Access Compliance Report

Public Rights-of-Way

(Curb Ramps)

Intersection ID: 24385	Main Street: BEVERLY_CREST_BV	Cross Street: BECKMORE_PL	Location: SE
ADA ID: E560CCBFF9BC	Ramp Type: Perp	Initial Pass/Fail: Fail	Overall Compliance: No
Severity Score: 12.5			
Codes/Mitigation Info/Possible Solution		Field Measurements/Component Compliance

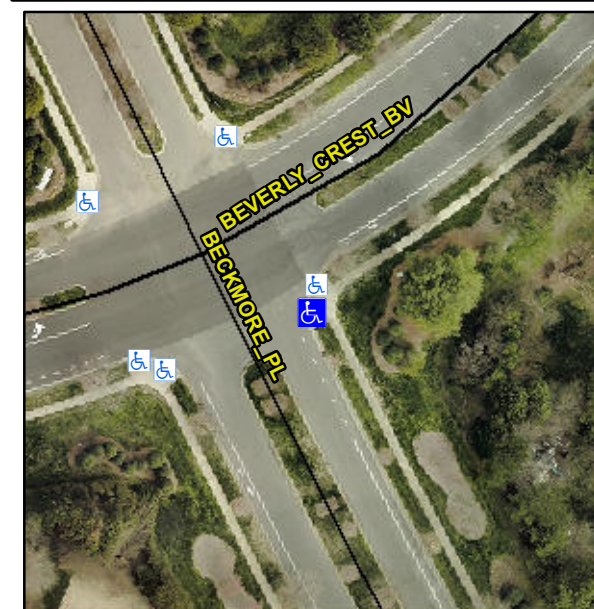
Not Found, R304.2.2

Compliance	Description	Data	Compliance	Description	Data
N/A	Ramp Length (in)	96.0	No	Ramp Slope (%)	8.4
Yes	Ramp Width (in)	81.0	Yes	Ramp XSlope (%)	0.9
N/A	Flare Type LT	N/A	N/A	Flare Type RT	N/A
N/A	Flare Slope LT (%)	N/A	N/A	Flare Slope RT (%)	N/A
N/A	Flare Traversable LT?	N/A	N/A	Flare Traversable RT?	N/A
N/A	Landing Length (in)	N/A	N/A	DWS Provided?	N/A
N/A	Landing Width (in)	N/A	N/A	DWS Contrast?	N/A
N/A	Landing Slope (%)	N/A	N/A	DWS Length (in)	N/A
N/A	Landing X Slope (%)	N/A	N/A	DWS Full Width?	N/A
N/A	Landing Curb? (Y/N)	N/A	N/A	DWS Offset (in)	N/A
N/A	Shared Landing?	N/A			
N/A	Gutter Ponding?	N/A	N/A	Gutter Slope (%)	N/A
N/A	Gutter Lip Ht (in)	N/A	N/A	Gutter X Slope (%)	N/A
N/A	Painted X Walk1?	No	N/A	Painted X Walk2?	N/A
	X Walk 1 Direction	To W		X Walk 2 Direction	N/A
N/A	X Walk 1 Width (in)	N/A	N/A	X Walk 2 Width (in)	N/A
	X Walk 1 Slope (%)	5.5		X Walk 2 Slope (%)	N/A
	X Walk 1 X Slope (%)	1.4		X Walk 2 X Slope (%)	N/A

Remove & Replace Entire Ramp.
